Palisades Nuclear Plant
NRC Docket 50-255
Renewed Facility Operating License No. DPR-20

Subject: Response to Request for Additional Information Regarding Relief Request
Number RR 5-10, *Proposed Alternative to ASME Section XI Code Requirements for
Modification of Reactor Pressure Vessel Head Vent Line Penetration*

Response to Request for Additional Information (RAI) Regarding Relief Request RR-5-10,
Modification of Reactor Vessel Closure Head Vent Line Penetration,

Drawings added for reviewer info only

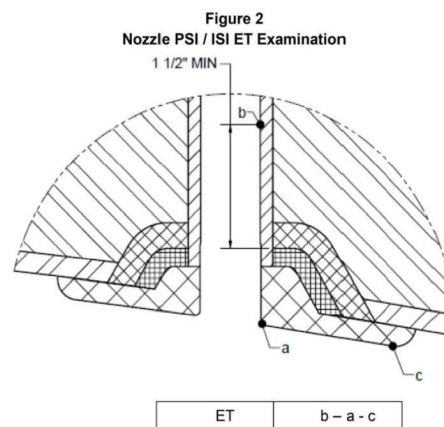
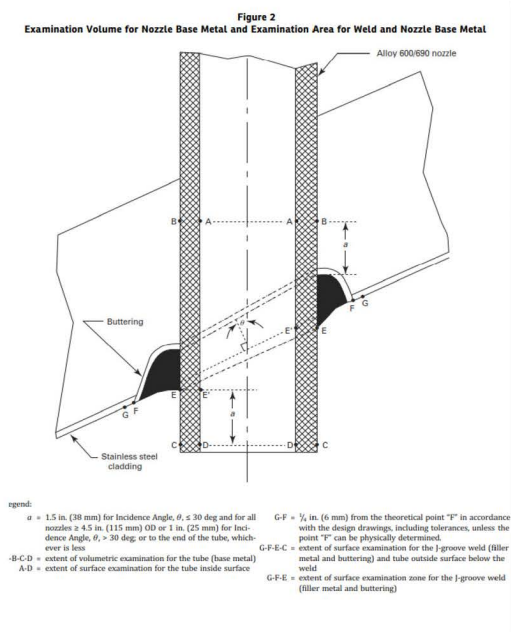
1. **NRC Question 1** – Confirm that the licensee’s proposed alternative in RR 5-10 is for the preservice and inservice surface examination coverage requirements to be changed from being, required to examine 1/4-inch beyond the Alloy 52M/152 weld-to-cladding interface shown in Figure 2 of ASME Code Case N-729-6, to instead only extend to point “c” of Figure 2 of RR 5-10.
 - a. Verify that the proposed alternative preservice and inservice surface examination coverage to point “c” of Figure 2 of RR 5-10 would bound the original Alloy 182/82 weld-to-cladding “G-F” dimension of Figure 2 of ASME Code Case N-729-6.

Palisades Response – As stated in the submittal letter this relief request is being revised to request relief for the Inservice Inspection (ISI) because the Preservice Inspection was satisfied by the Liquid Penetrant (PT) test which has been performed. Relief is only being requested from the ISI requirement to examine 1/4-inch beyond the Alloy 52M/152 weld-to-cladding interface shown in Figure 2 of Code Case N-729-6. Requested examination coverage on the outer face of the weld extends from point “a” to point “c” as shown in Figure 2 of the submittal.

- a. The alternative surface examination coverage bounds the 1/4-inch “G-F” dimension provided in Figure 2 of ASME Code Case N-729-6.

Note: Extent of examination above the original J-groove weld is 1-1/2". The extent of examination on the surface of the new weld covers the ground face of the pad, excluding the blended radius between the new weld and the RVCH cladding.

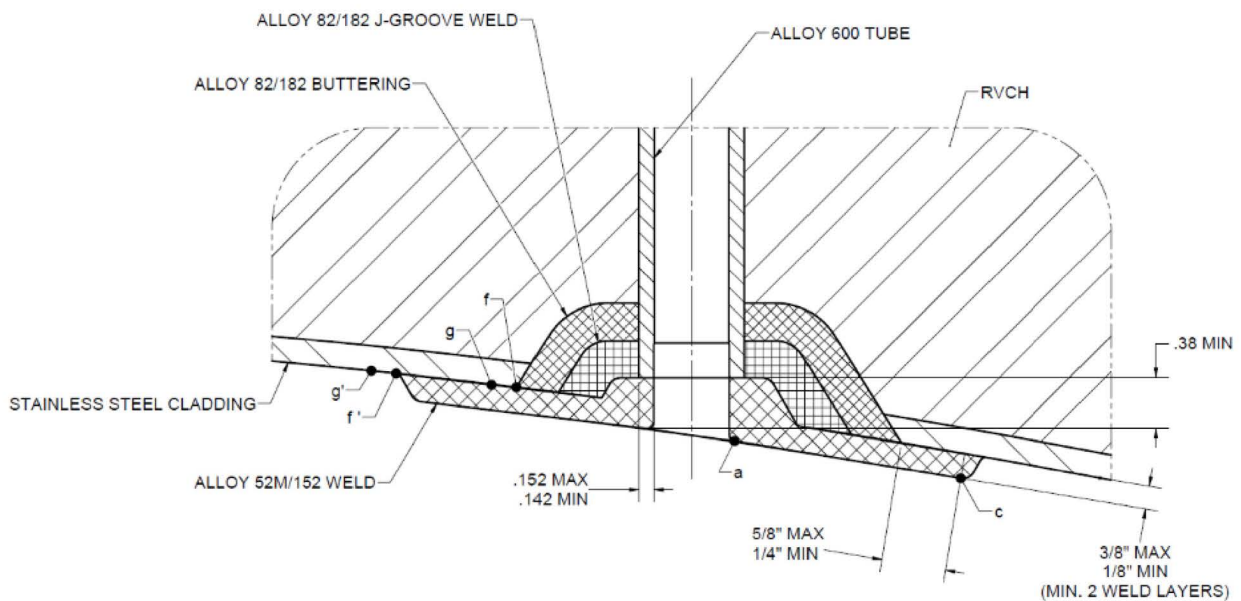
2. **NRC Question 2** - Figures 1 and 2 of RR 5-10 lack detailed dimensions of the modification. Provide a drawing of the modification including Alloy 52 weld metal deposit thickness ranges and coverage lengths over the Alloy 600 tube, Alloy 182/82 weld metal, and stainless steel cladding

Palisades Response – See below:
